**TOWN OF PORTOLA VALLEY
ARCHITECTURAL AND SITE CONTROL COMMISSION (ASCC)
Monday, February 24, 2014
7:30 PM – Regular ASCC Meeting
Historic Schoolhouse
765 Portola Road, Portola Valley, CA 94028**

MEMORANDUM

RE: Continued review for conformity with CUP X7D-30 and for Site Development Permit X9H-668: New building at Benedictine Square and proposed changes to Benedictine and Church Squares

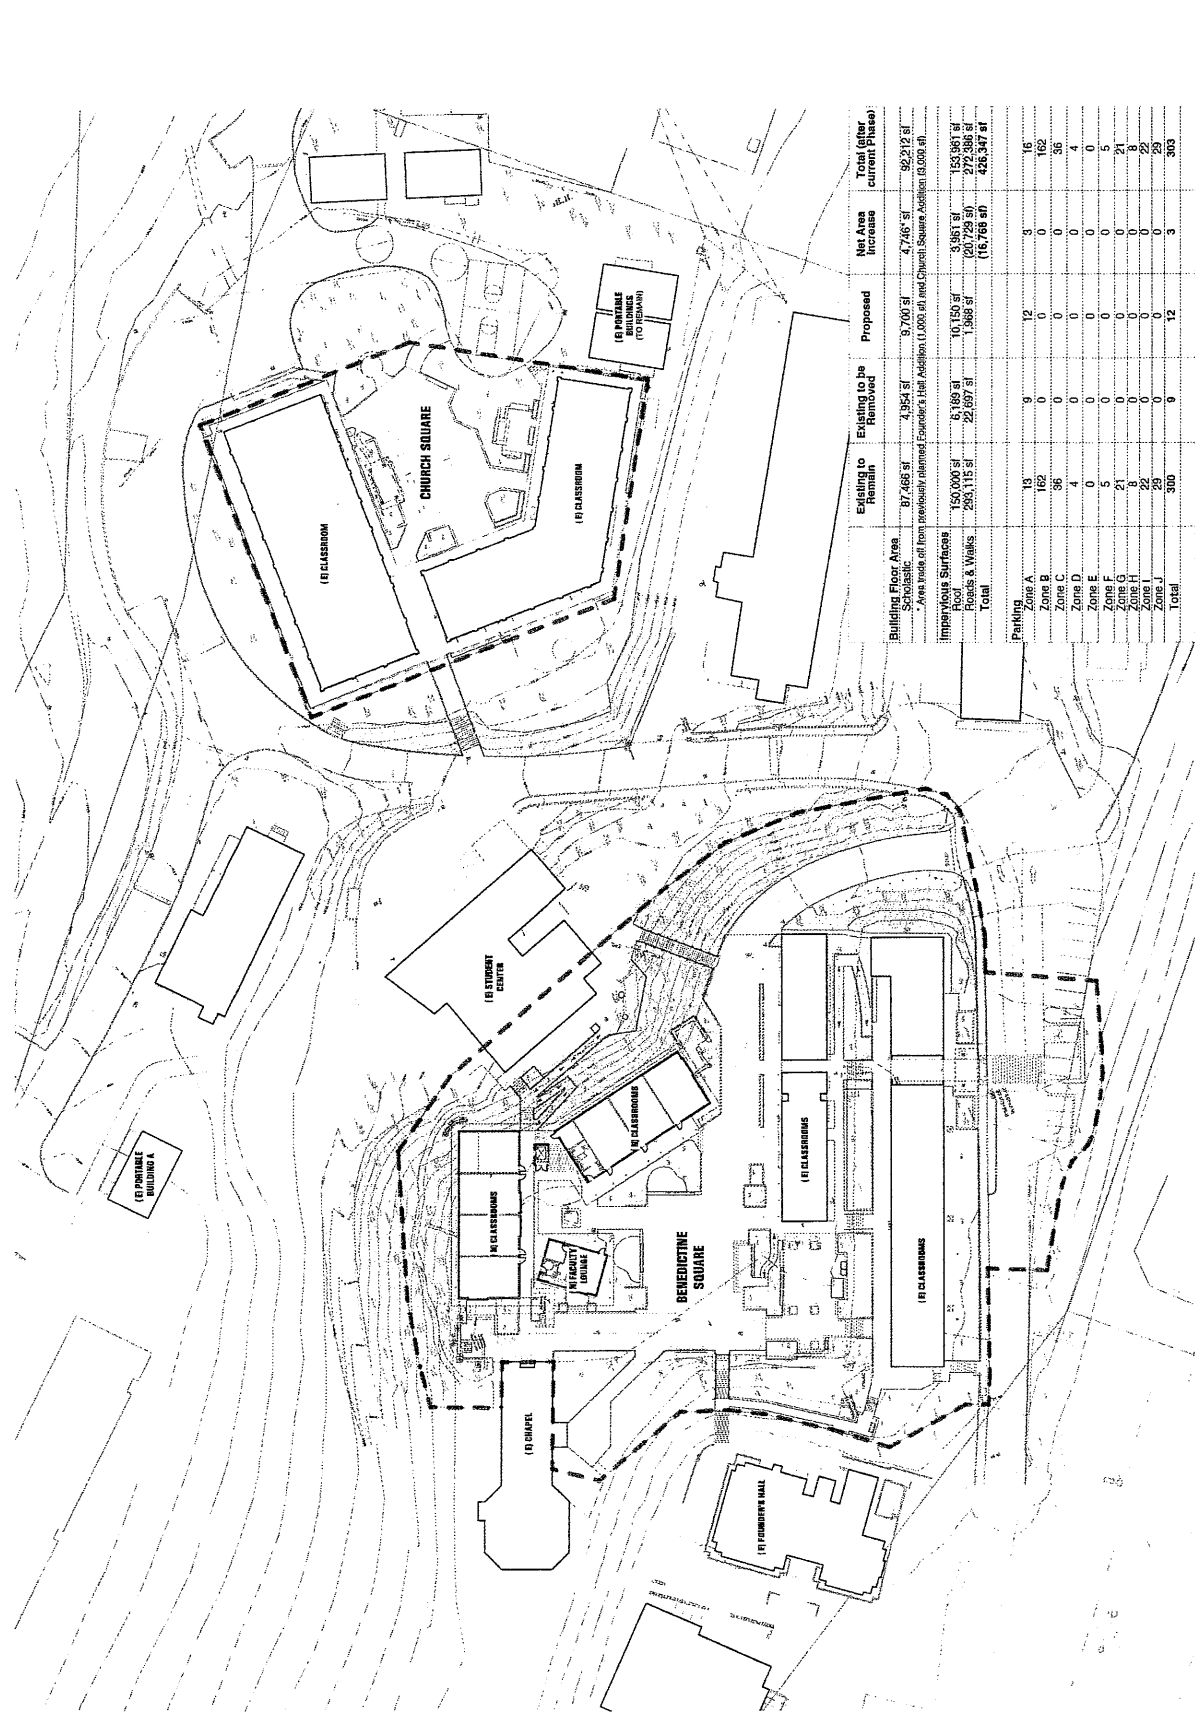
The Master Plan includes floor area and impervious surface limits for the campus, and the project team will need to provide final, detailed calculations to demonstrate compliance with the CUP limits. Sheet A1.1 now contains calculations of how the project fits with the floor area and impervious surface limits. Staff is working with the applicant to document and finalize these numbers. Based on the information provided to date, however, it appears that the project will not exceed the overall floor area or impervious surface limits for the campus.

Sheet A1.1 also shows the status of CUP required and existing parking on the campus. The campus had a total of 261 parking spaces in 2005; under the approved

master plan, the amount of parking was to increase to 325 spaces. The revised project plans appear to show a change in the configuration of the parking along the entry road across from the existing classrooms at Benedictine Square, and three additional parking spaces that would be provided through this change. Confirmation of the change in the parking configuration is still needed. As a result, the on-campus parking would increase with this project to 303 parking spaces. This appears to be in substantial compliance with the master plan given where the school is in the process of implementing its plan.

2. Compliance with the floor area and impervious surface limits set forth in the approved Priory Master Plan shall be demonstrated to the satisfaction of staff prior to the issuance of any permits for this project.

3. Prior to the issuance of a site development permit, details of the area where the parking configuration will be changed shall be provided to the satisfaction of staff, showing the spaces to be removed and the spaces to be added.

1 SOUTH ELEVATION
 Scale: 3/16" = 1'-0"

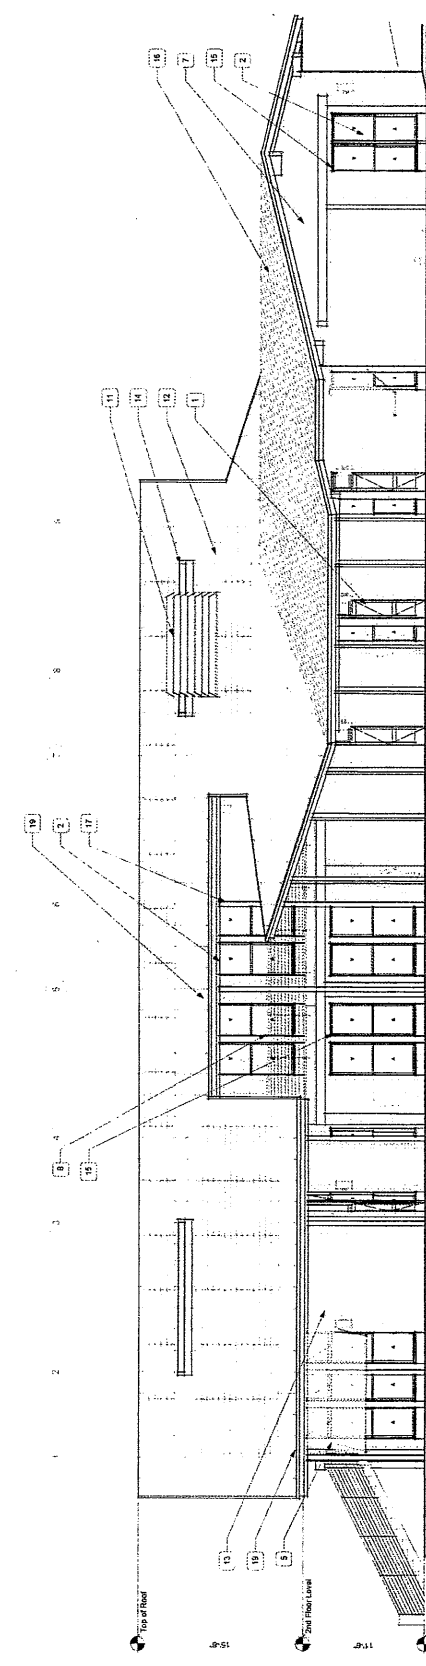
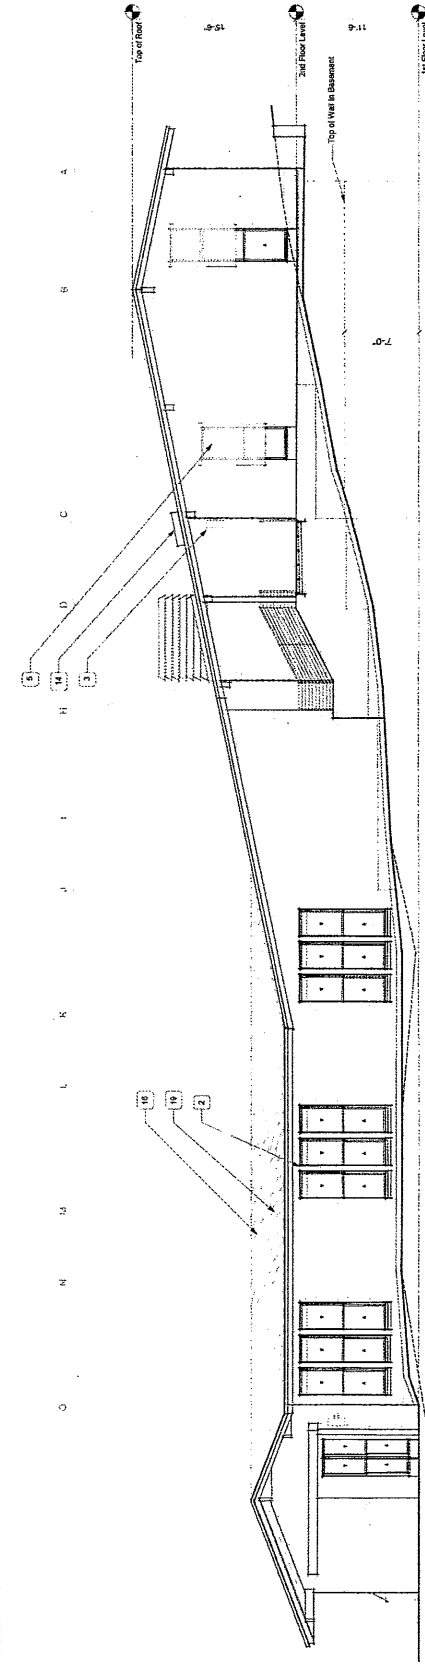
3. **Changes to project design, building heights, and exterior materials.** The February 10 plan set contains revised elevations with the modified building design which demonstrate conformity with the town's height limit. In addition, the staircase shown on the western elevation has been reconfigured, and the elevations reflect other minor changes to the plans. However, the buildings as shown on the elevations are substantially the same as the elevations in the January 24 plan set as modeled and evaluated at the February 10 site meeting. Materials for the project have not changed.

The elevations now show all of the proposed locations for the fabric awnings. A new sheet, R1.0, shows renderings of the buildings including the awnings, with the awnings shown in an off-white color. The applicant should confirm at the February 24 meeting whether the awning color has been finalized; if not, the color could be approved by a designated member of the ASCC. A condition of approval is suggested stating that approval of the awnings is for the new buildings within Benedictine Square only and specifically does not apply to the Student Center. Also, as discussed at the evening meeting on February 10, the ASCC could allow flexibility for the awning colors, but only for the locations considered and found acceptable during the last site meeting.

9. Priory to issuance of a building permit, information on the final size and height of the deck shall be provided to the satisfaction of staff.
 10. Awnings shall only be permitted in the locations shown on the February 10, 2014 plans, and this project specifically does not include any awnings on the Student Center.

1 STUDENT CENTER IMPROVEMENTS

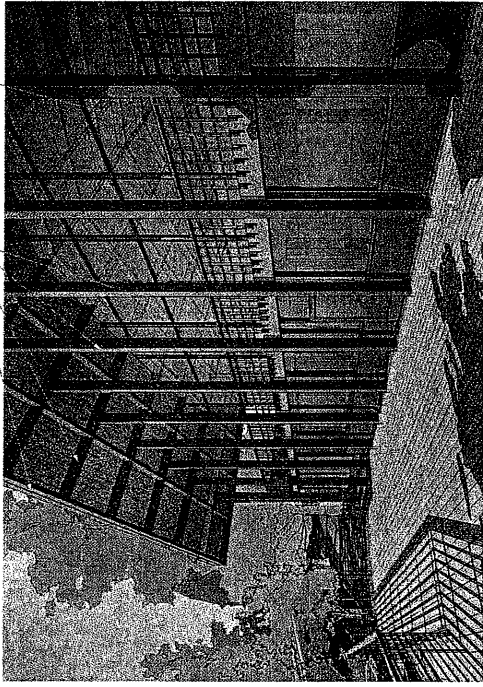
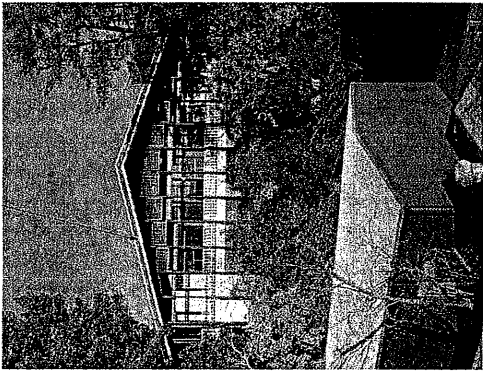
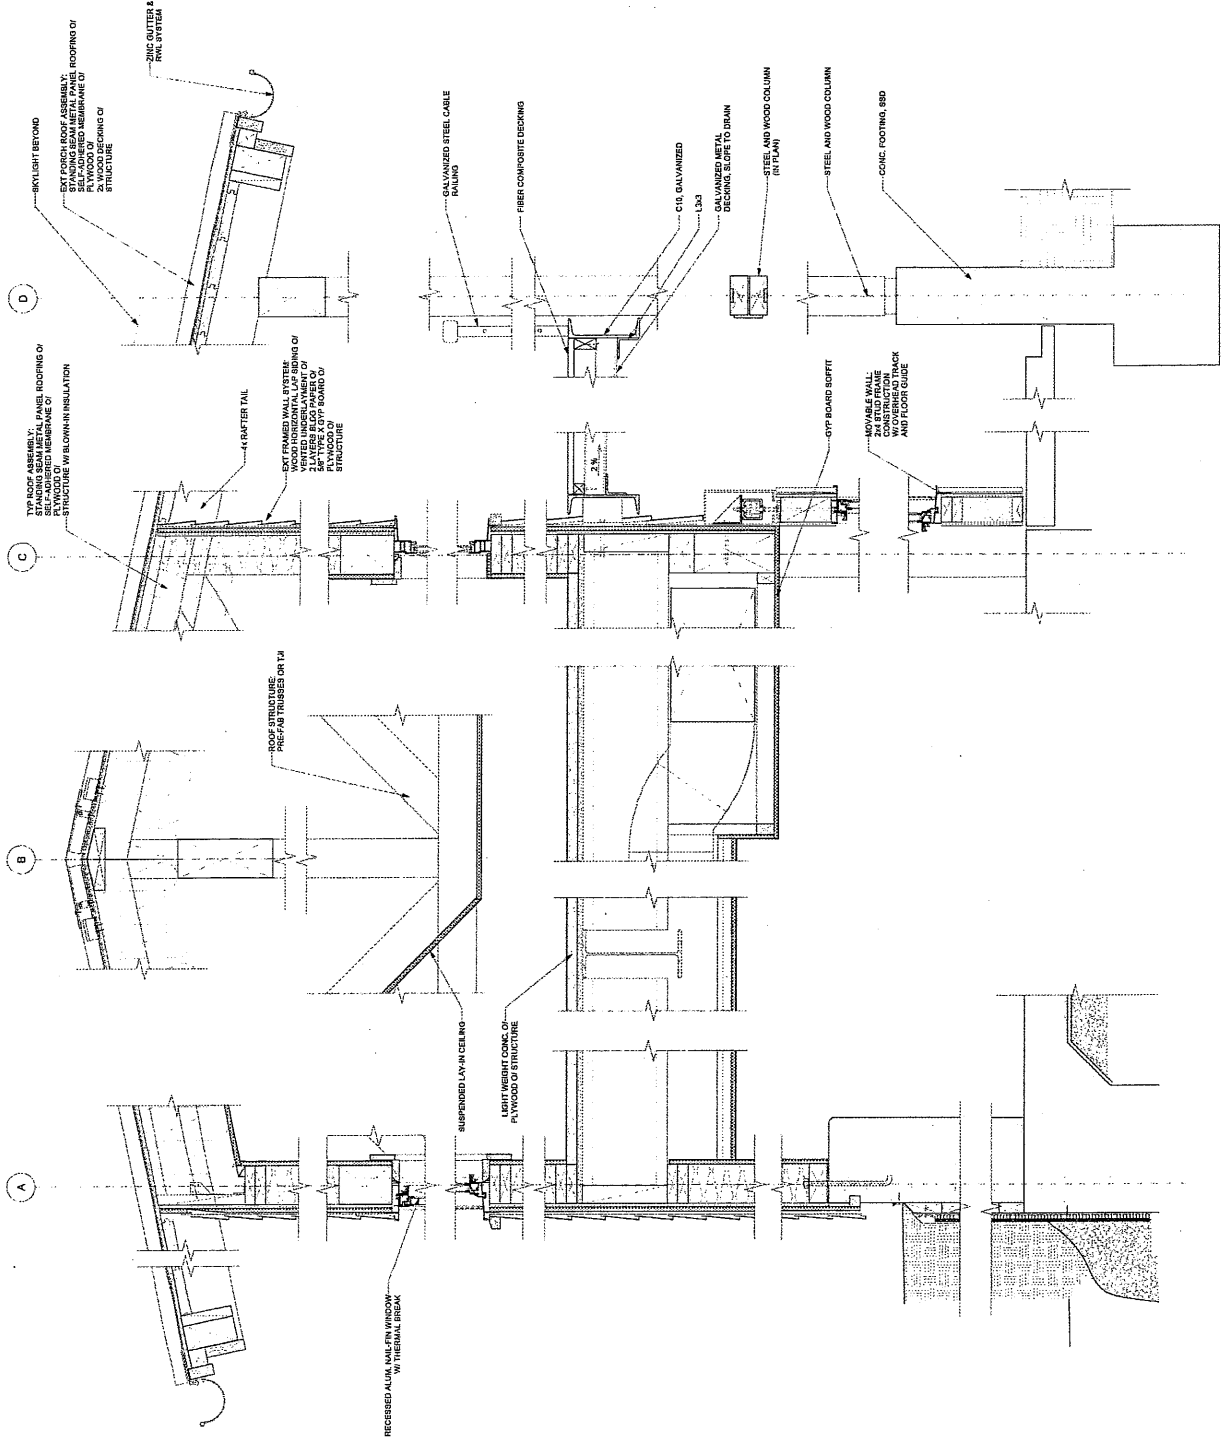
The project team has included improvements to the Student Center as part of the project plans. These are shown on Sheet A4.1 and consist of painting the columns, rafters and railings on the west face of the Student Center brown, instead of their existing black and white colors.

The project would also include adding a new deck that would overlook Benedictine Square. The deck would replace the existing concrete patio in this location and would be larger than the patio. The deck would use a Resysta composite decking material with an untreated finish, which is shown on the materials board and is consistent with Town standards. At this point, the understanding is that the deck will be no more than approximately 30" high, but information on the final size and height of the deck is still needed and can be provided to the satisfaction of staff.

1 PROPOSED SITE LIGHTING

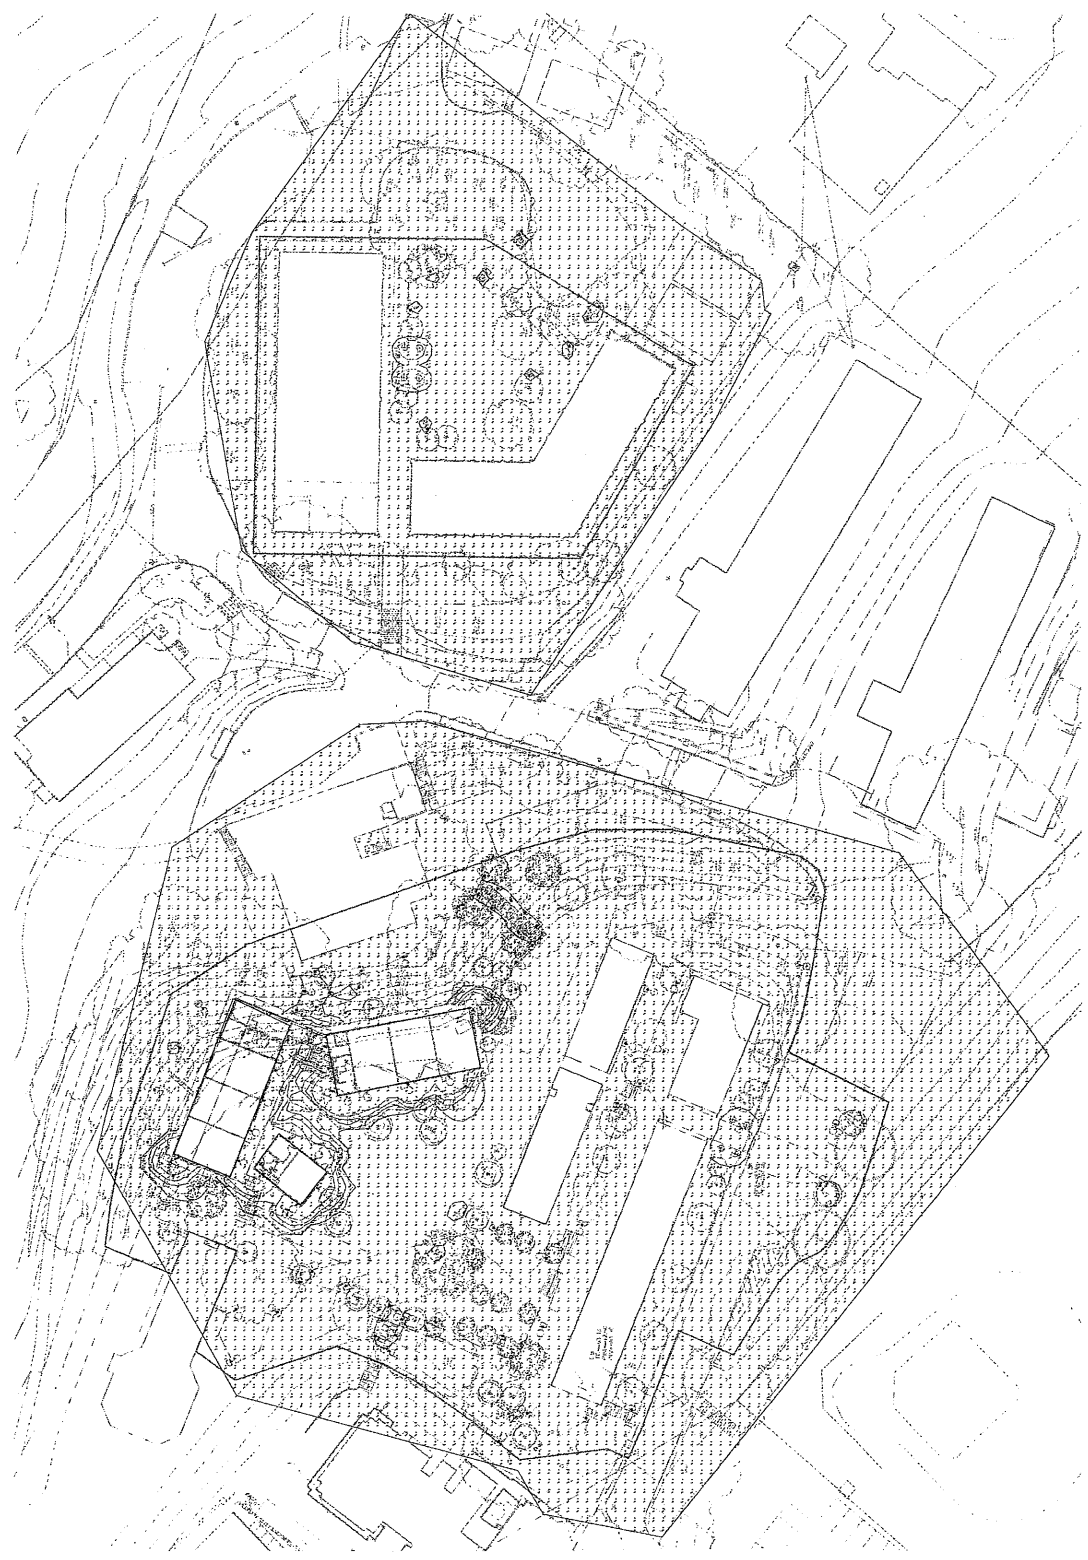
6. **Revised lighting plan.** The revised lighting plan, as shown on Sheet A1.2, shows significantly fewer lights than was shown on the January 24 submittal. All of the lighting in the trees and landscaped areas has been removed. Lighting in Benedictine Square would be provided through a combination of wall sconces located on the new buildings, bollard path lights, and wall lights that would be mounted on retaining walls. In Church Square, lighting would be provided with bollard path lights and four downlights in the proposed trellis feature. The designs of these fixtures are consistent with the Priory’s Master Lighting and Landscaping Plan.

The brightness of the bollard and wall lights is listed as one LED with a maximum of 52 lumens, but information on the brightness of the wall sconce and the downlight is still needed. Assuming that these comply with Town standards, the overall level of lighting would also appear to be consistent with the provisions of the approved CUP Lighting and Landscaping Plan.

7. Prior to issuance of a building permit, the architect shall provide information on the proposed brightness of the wall sconce and downlight fixtures (number of LEDs or lumens), to the satisfaction of staff.

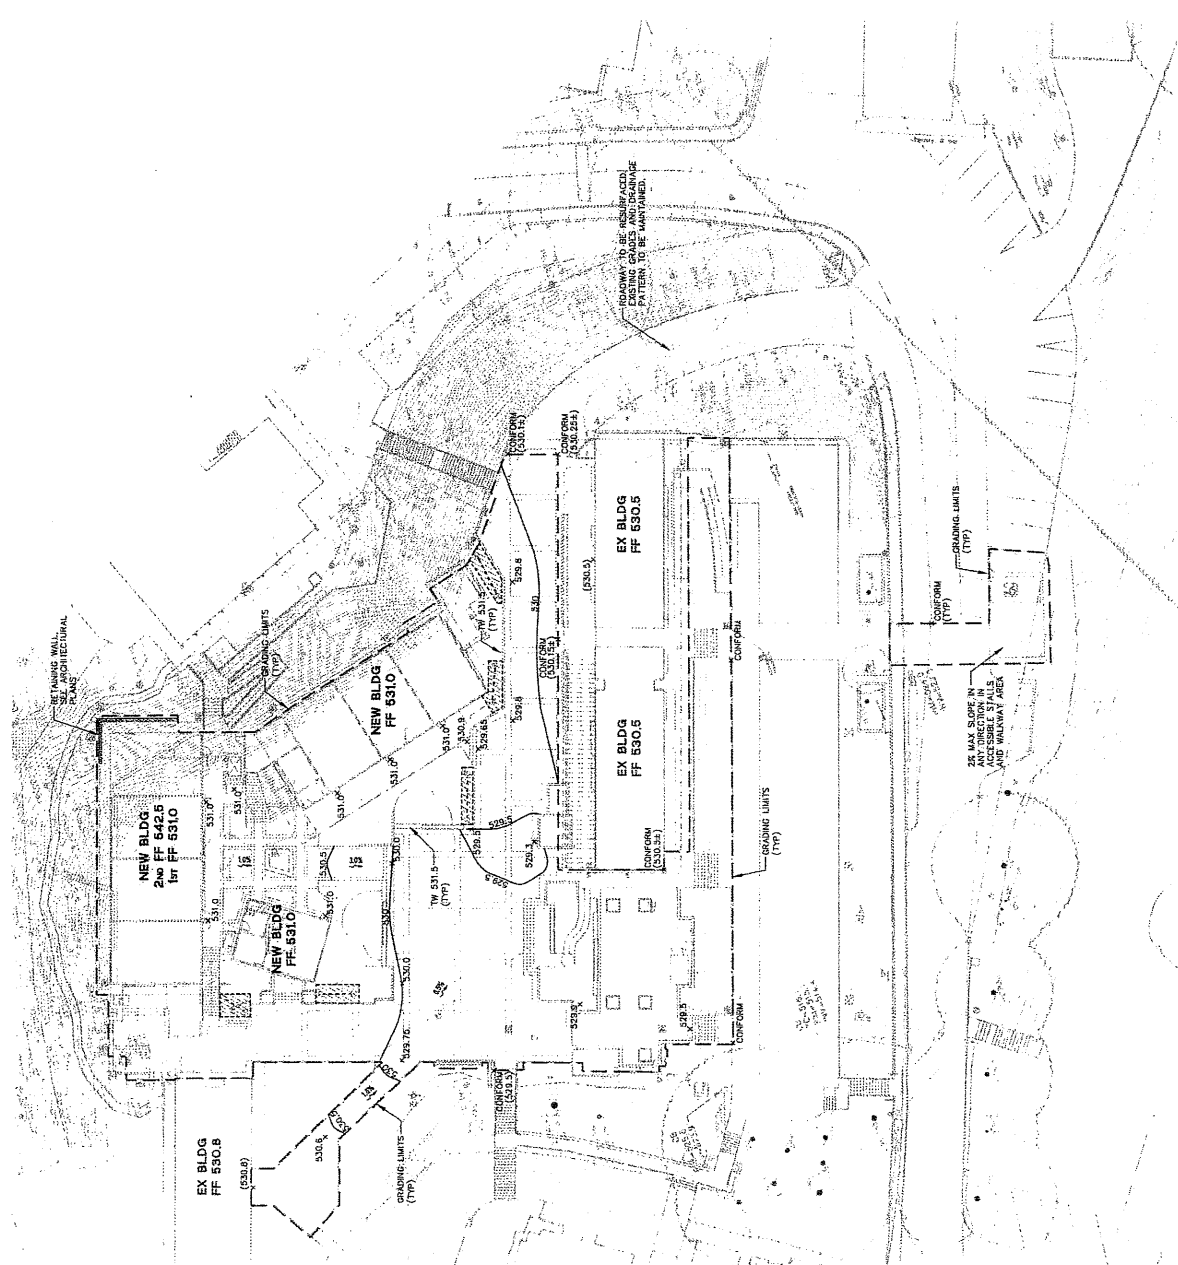
2. **Site Development Permit, Storm Drainage, and Project Staging.** Conceptual grading plans are provided on Sheets C3.0 (Benedictine Square), C3.1 (Church Square), and C3.2 (Portable Building A Relocation). These grading plans show less grading than was anticipated at the last meeting. However, the plans do not appear to include the grading for the wheelchair ramp at the north end of the Student Center and may be missing other items as well. Submittal of engineered grading plans and approval by the Public Works Director, Town Geologist, and Fire Marshal will be necessary before the site development permit could be issued.

Although the grading plans provide total earthwork numbers, these do not appear to account for the work that will be needed to remove the current pavers and install nine inches of drain rock under the new pavers. This volume of earthwork will need to be accounted for in the construction staging plan for the project. In addition, the construction staging plan will need to demonstrate coordination with the construction staging plan for the track and field project. The two staging plans will need to show that there is sufficient on-campus parking for all construction workers throughout both projects, as well as appropriate storage areas for materials that are being removed and brought in for both projects, and both will need to identify and address any potential impacts on traffic. Timing relative to normal school year site demands will be an important consideration for the applicant and for the Town in reviewing and acting on the final construction staging plan. The final plan should include a detailed time schedule developed by the project architects and construction contractors.

4. Engineered grading plans that are in substantial conformity with the conceptual grading plans shown on Sheets C3.0, C3.1, and C3.2 shall be provided prior to the issuance of a site development permit and shall be to the satisfaction of planning staff and the Public Works Director.
